Commentary on 'Modified MMF (Morgan–Morgan–Finney) model for evaluating effects of crops and vegetation cover on soil erosion' by Morgan and Duzant (2008)

Abstract: The Morgan–Morgan–Finney (MMF) model is a widely used semi-physically based soil erosion model that has been tested and validated in various land use types and climatic regions. The latest version of the model, the modified MMF (MMMF) model, improved its conceptual physical representations through several modifications of the original model. However, the MMMF model has three problematic parts to be corrected: 1) the effective rainfall equation, 2) the interflow equation, and 3) the improperly normalized C-factor of the transport capacity equation. In this commentary, we identify and correct the problematic parts of the MMMF model, which should result in more accurate estimations of runoff and soil erosion rates.

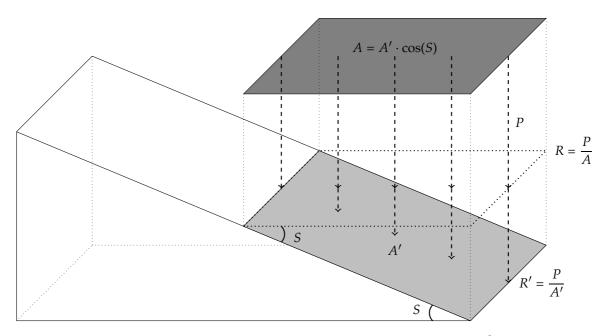
However, we argue that in order to calculate effective rainfall correctly, $\cos(S)$ should be used as a sloping adjustment factor rather than $\frac{1}{\cos(S)}$ as described in Sharon [21] and Tani [22]. We demonstrate our claims through mathematical proof and in Figure 1.

Let us consider an element on a hill slope with an angle of S (°). Assuming that the area in the horizontal plane is A (m²) and its projected area on the element is A' (m²), the trigonometric relationship between A and A' is

$$A = A' \cdot \cos(S). \tag{2}$$

Because the total volume of rainfall (*P*; L) is the same for both *A* and *A*' (Figure 1), the amount of rainfall per unit area for *A* and *A*' can be calculated as

$$R' = \frac{P}{A'} = \frac{P}{A} \cdot \cos(S) = R \cdot \cos(S) \tag{5}$$

$$Rf_{\text{corrected}} = R' \cdot (1 - PI) = R \cdot (1 - PI) \cdot \cos(S).$$
(6)

Thus, the slope adjustment factor should be cos(S) rather than $\frac{1}{cos(S)}$ in order to calculate effective rainfall (*Rf*) considering the slope.

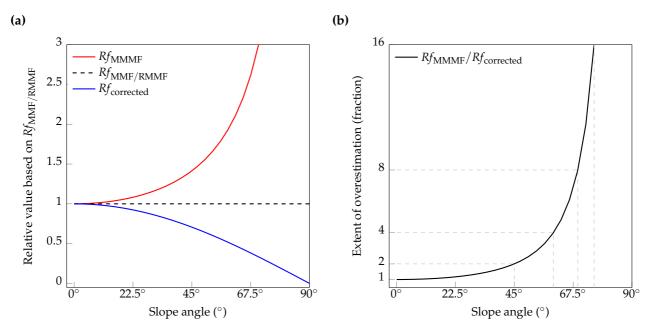
Owing to the problematic slope adjustment factor of the effective rainfall suggested by Morgan and Duzant (2008), the model overestimates the effective rainfall when the slope of an element increases, as shown in Figure 2.

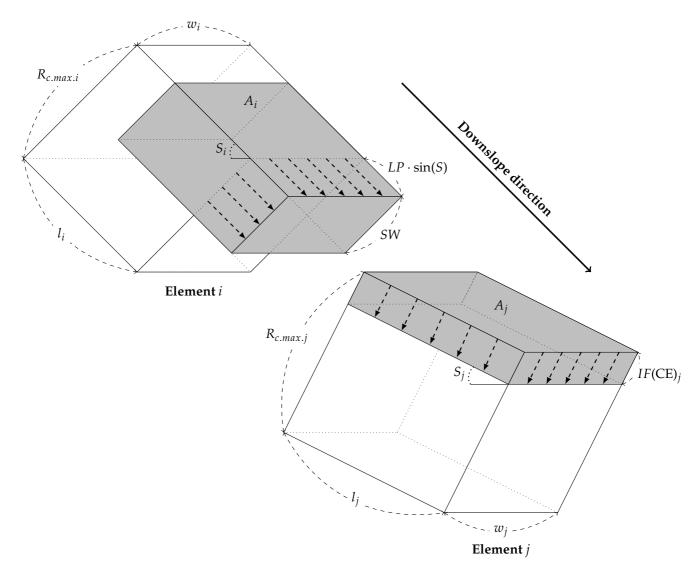
In the MMMF model, the unit of IF_{MMMF} is defined as volume per unit area (L m⁻² = mm), which is similar to other hydrological quantities in the model (i.e., R, Rf, R_c , E, and Q). However, the unit of interflow in equation (7), which is depth multiplied by velocity (or length for daily time steps), contradicts the definition of IF_{MMMF} as depth (mm) in the model.

We argue that the interflow equation is improperly formulated and that the IF_{MMMF} has the wrong unit. Let us consider the interflow generated from an element *i*, as shown in Figure 3.

$$V_{IF} = SW \cdot LP \cdot \sin(S_i) \cdot w_i. \tag{9}$$

V_{IF} is the depth of soil water (*SW*) multiplied by the travel distance of the interflow ($LP \cdot sin(S)$) and the width of the element (w_i), as represented in Figure 3. Equivalent to other hydrological quantities,

Another problem exists in the interflow equation even if $IF_{\text{corrected}}$ is used rather than IF_{MMMF} . As shown in Figure 3, the generated interflow from the element *i* flows into the element *j*. Because the total volume of interflow (V_{IF}) is the same for both elements, the interflow into the element *j* ($IF(\text{CE})_i$) should be

$$IF(CE)_j = \frac{V_{IF}}{A_j} \neq \frac{V_{IF}}{A_i} = IF_i.$$
(12)

$$IF_{\text{corrected}} = \left(\frac{R - E - Q}{365}\right) \cdot \left(LP \cdot \sin(S_i)\right) \cdot \frac{1}{l_i} = \frac{IF_{\text{MMMF}}}{l_i}.$$
 (11)

Therefore, the additional term of $\frac{1}{l_i}$ is required for the interflow equation of Morgan and Duzant [9]. Furthermore, with this term, $IF_{\text{corrected}}$ has the correct unit of depth (mm). The dependence of interflow on slope length is obvious, as shown in the lateral flow equation of the widely used SWAT model (equation 2:3.5.9 of Neitsch *et al.* [2]), because the SWAT model also uses water volume per unit area. We derived the same formula of $IF_{\text{corrected}}$ by using the theoretically well-established Darcy's law in the supplementary material of this article.

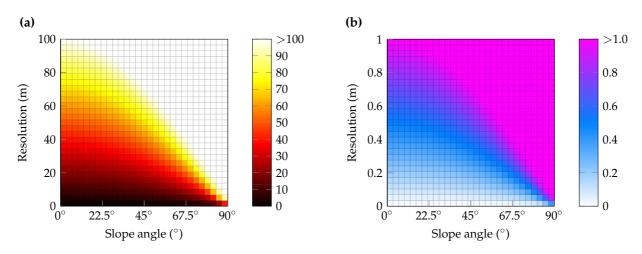
Owing to the incorrect formula in the interflow equation of Morgan and Duzant [9], the MMMF model overestimates interflow when the slope length of an element increases. However, the model underestimates interflow if the slope length of an element is less than 1 m. Figure 4 shows the extent of the overestimation when the MMMF model is applied to raster maps such as a digital elevation model (DEM). For a DEM with a certain resolution (*res*; m), the width (*w*) and the length (*l*) of each element are equal to *res* and $\frac{res}{\cos(S)}$. Therefore, the extent of overestimation of the interflow is dependent on the slope of an element and the resolution of the DEM.

In the case of Setiawan [19], who applied the MMMF model using a DEM with 0.05 m resolution for a maximum slope of 41°, the MMMF model estimated at most only 7% of the corrected interflow. In the case of Lilhare *et al.* [10], who applied the MMMF model using a DEM with 90 m resolution, the extent of overestimation was more than 90 times compared with the corrected interflow. Owing to the discrepancy between the generated and transferred interflow, the model overestimates the interflow from contributing elements to a receiving element when the receiving element is steeper than the contributing elements, as shown in Figure 5. In addition, the model underestimates the interflow from contributing elements when they are steeper than the receiving element. The extent of the discrepancy increases with the increase in slope differences between contributing and receiving elements.

Figure S1. Conceptual representation of soil water in an element. *A*, *w*, *l*, and *S* are the area (m²), width (m), slope length (m), and slope angle (°) of the element, respectively; *SW* (mm) is the daily mean soil water over one year, and σ_a (m²) is the cross-sectional area of *SW*.

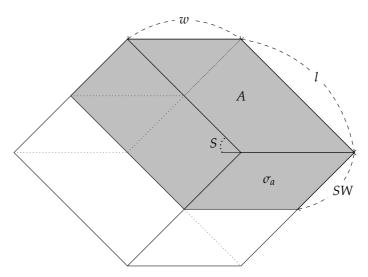
Let us assume that there is an amount of soil water equivalent to the daily mean soil water over one year (*SW*; mm) in an element and that only soil water exerts a force on the element for the interflow process (Figure S1).

$$IF_{\text{corrected}} = 1000 \cdot \frac{V_{SW.out}}{A} = \frac{LP \cdot SW \cdot w \cdot \sin(S)}{l},\tag{S7}$$
